From: [Joe Tierney](#)
To: [Alex Elvin](#)
Subject: RE: Stillpoint question
Date: Monday, April 3, 2023 1:45:00 PM
Attachments: [795 state rd- septic plan.pdf](#)

Hope all is well. The MVC hearing officer asked if you could clarify the following in regard to the Stillpoint project:

Proposed Septic System on Land in West Tisbury, MASS.

Designed for: Polly Hill Arboretum
Street Address: #809 State Road
Assessor No.: 25-2
Lot Area: ±19.52 acres
Designed By: Troy Silva
Checked By: R.G.S.
Date: June 26, 2022
Revised: 7/12/22 - Relocate Water and Electric Lines

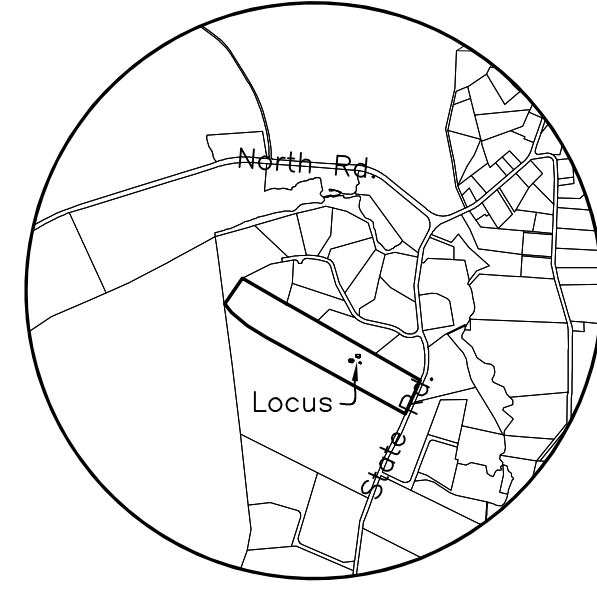
(1) what is the distance between the closest Polly Hill staff dwelling and the lot line Polly Hill shares with the Stillpoint barn lot (4.11)?

(2) what is the zoning setback requirement for that lot line?

As I stated in our conversation setbacks are 50' all sides.
